1989 Model V6 Outboards – 40 AMP Charging System

Figure 1.

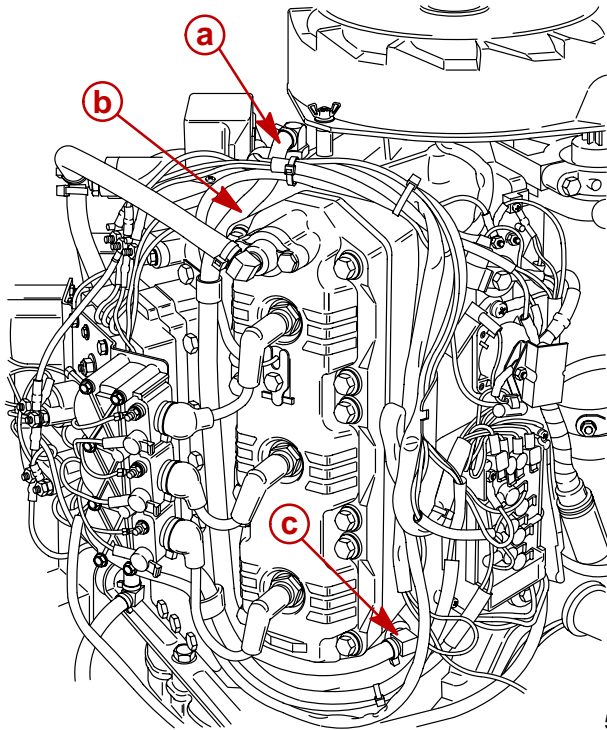
Recently a concern was discovered in cooling the watercooled voltage regulator for the 40 amp charging system. It was found that prolonged idling could allow a steam pocket to grow in the cylinder block, to the point that the cooling fins, on the bottom of the regulator, are not fully submerged in water. While this does not effect the operation of the outboard, the regulator has a thermo-safety switch built in. Therefore, if the regulator temperature gets to a critical point it shuts off the charging system which over a period of time could result in a discharged battery.

To solve this problem, route the poppet bypass water out the top of the block and eliminate the 3/8" hole at the bottom of the block. This will route the water externally back into the poppet valve area thru a fitting in the relief valve cover. (Figure 1) This will eliminate this situation at all engine speeds.

A Water Bypass Kit P/N 814654A1 is available for this modification. Should a customer indicate that their battery is not charging properly, it may be necessary to install the bypass kit. This installation of the kit will be covered under warranty.

Figure 2.

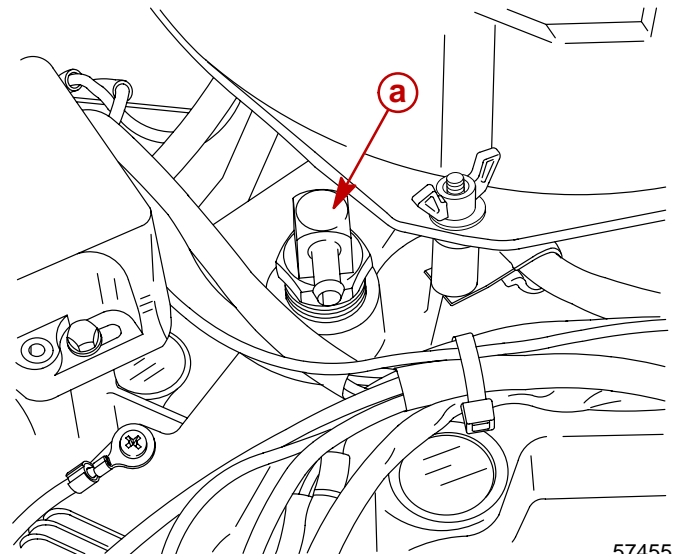
Future V6 cylinder blocks and short blocks will not have the pipe plug installed in the top of the block. An elbow will replace the pipe plug. (Figure 2)

Production V6 Outboards Serial No. 0C164371 and above will have the water bypass installed.
